TOWN OF ERIE
PLANNING COMMISSION AGENDA ITEM
Meeting Date: July 18, 2018

SUBJECT:	GENERAL BUSINESS:
	A Sketch Plan Review of Parkdale No. 2
CODE REVIEW:	Erie Municipal Code, Title 10
PURPOSE:	A Sketch Plan represents a generalized land use plan and layout for the area proposed to be included within a subdivision. A Sketch Plan application is required to allow for an early, informal evaluation of a proposed subdivision before detailed planning and engineering work has occurred.
DEPARTMENT:	Planning & Development
PRESENTER:	Audem Gonzales, Planner

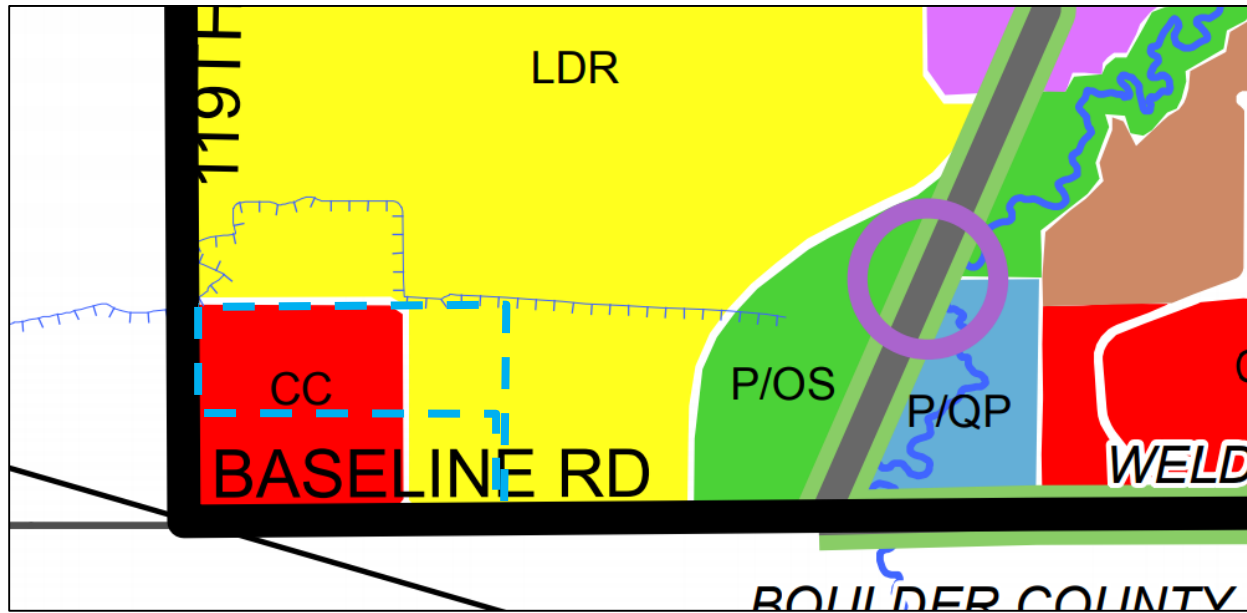
The Parkdale Sketch Plan No. 2 application proposes to add a new area of development to the Parkdale subdivision. A collector road heading east from 119th Street provides access to the residential subdivision. This collector will also provide a connection for commercial development to the south. The sketch plan also incorporates several road stubs to adjacent properties that could develop in the future.

The development proposes two single-family detached lot types and one paired home lot type. Each home is proposed to be alley-loaded. Where homes do not have street frontage the applicant has provided 30-foot wide garden courts.
